RHODE ISLAND CONTRACT NO. 2002-CH-091

Statewide ADA Compliance Project; Accessibility Improvements to Pawtucket Avenue (Route 103) and Mineral Spring Avenue (Route 15)

ADDENDUM NO. 1

1. Sheet 14 - General, Drainage & Utility Plan No. 8

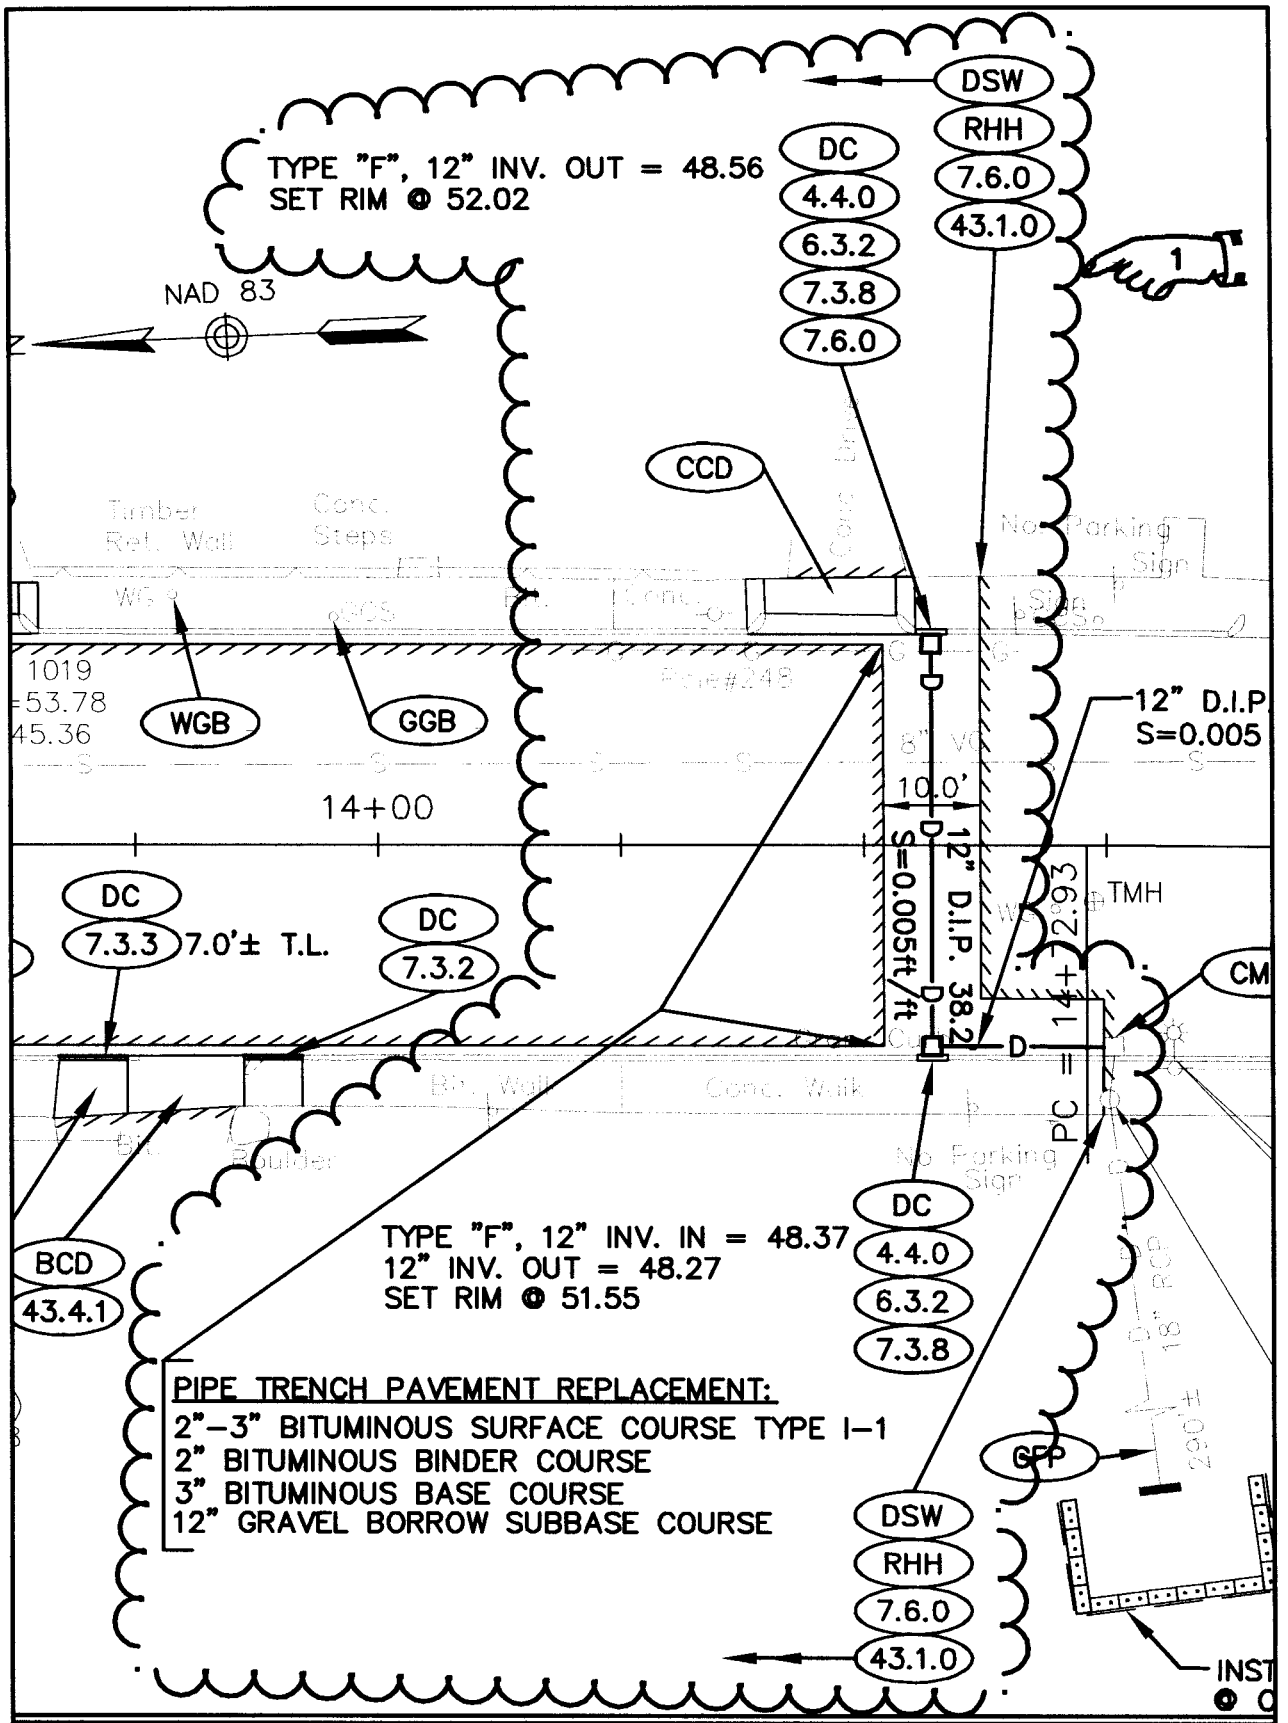
Revise the entire area bound by the revision cloud as shown on Sketch No. 1 attached to this Addendum No. 1. The limits of the sidewalk and driveway work have been extended to the terminus of the proposed drainage improvements at Sta. 14+57. Excavation and pavement replacement limits have also been shown.
